BRIDGE #104

Report on
SOIL INVESTIGATION
for
ROAD BRIDGE NO. 104, ROAD 18
COUNTY OF MIDDLESEX

-- Site Visit --
Bridge No. 104, County Road 18
County of Middlesex
District No. 2

County of Middlesex,
Bridge #104, County Rd. #18,
Twp. McGillivray, Lot 20, Con. V,
Twp. West Williams, Lot 20, Con. XX,
Structure Site No. 20-29,
Your File No. BA 1601.

COUNTY BRIDGE #104			
COUNTY OF MIDDLESEX			
SCALE: AS SHOWN	APPROVED BY:	JOB NO.	DRAWN BY: W.R.
DATE:	Misc.	REVISED	
RECORDED ELEVATIONS & DIMENSIONS FOR STABILITY OBSERVATIONS			
A.M. SPRIET & ASSOCIATES LTD.		CONSULTING ENGINEERS

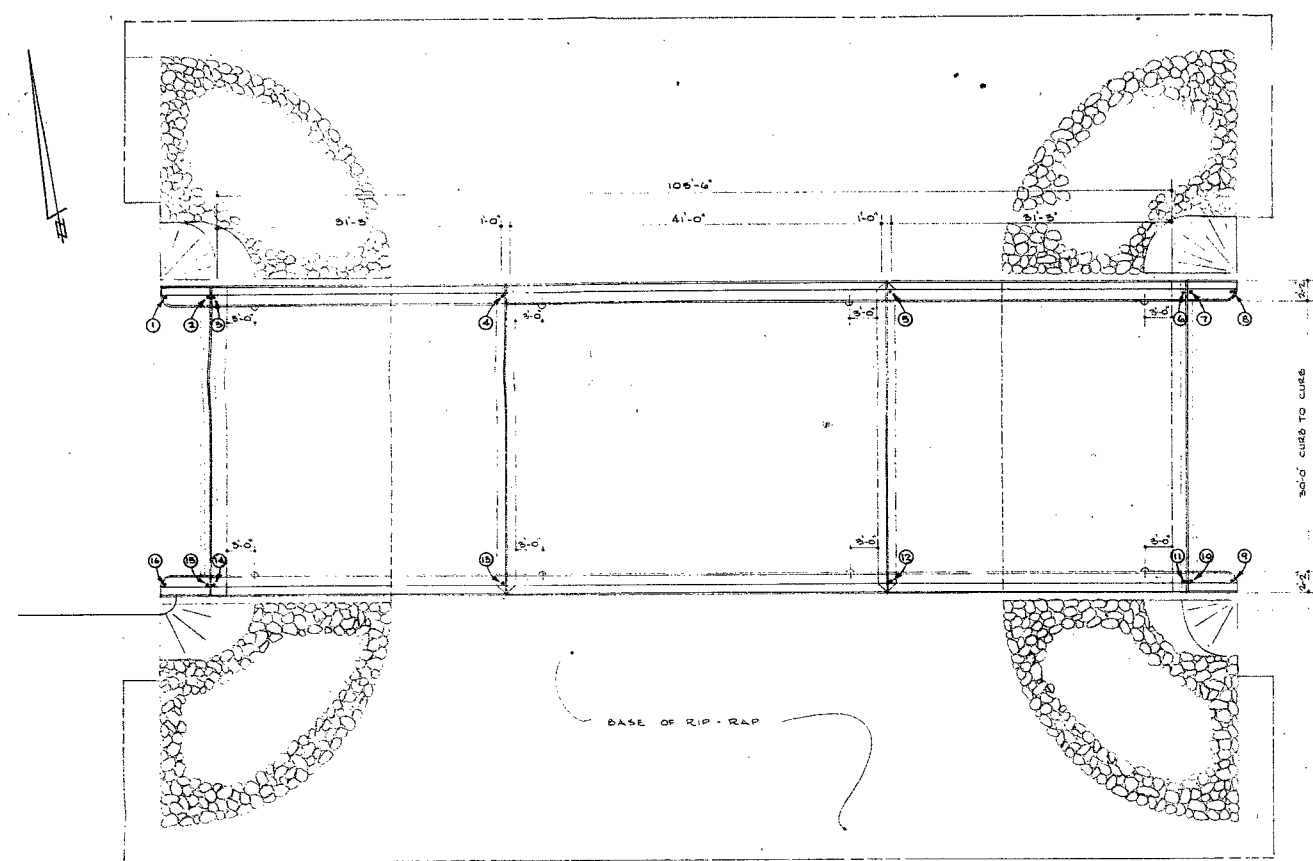
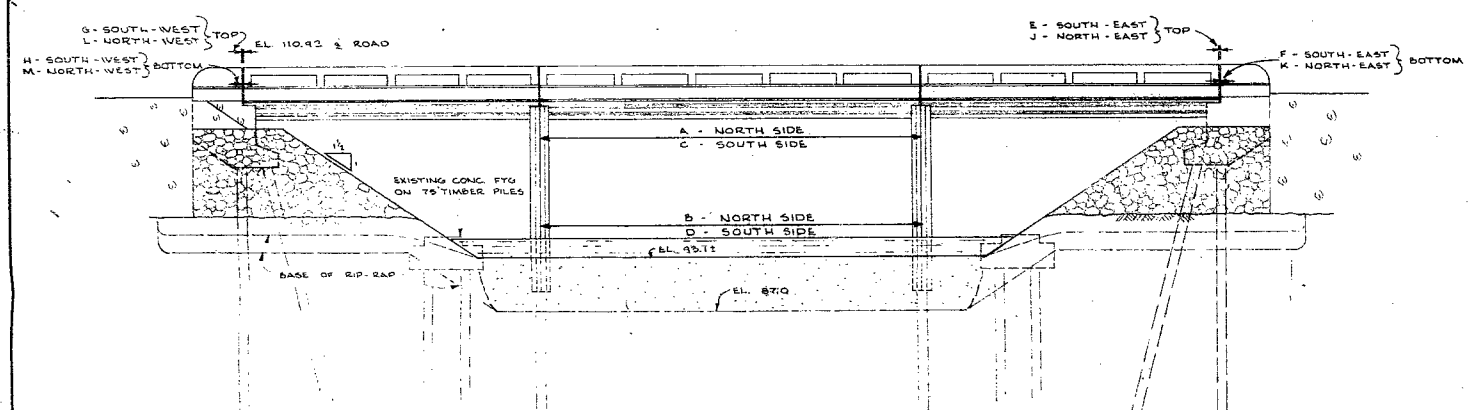
It is our opinion that these readings should be continued on a monthly basis in order to provide a reliable record of bridge movements. There seems to be no doubt that movements have occurred. However, they may have stopped by now, or there might be a decreasing tendency. The monthly readings should provide an answer to this question.

We would also suggest that the reliability of the bench mark (nail in hydro pole) be checked and that efforts be made to have a more permanent bench mark established. It is our experience that due to the doubtful reliability of the bench mark, many observations and readings had questionable value.
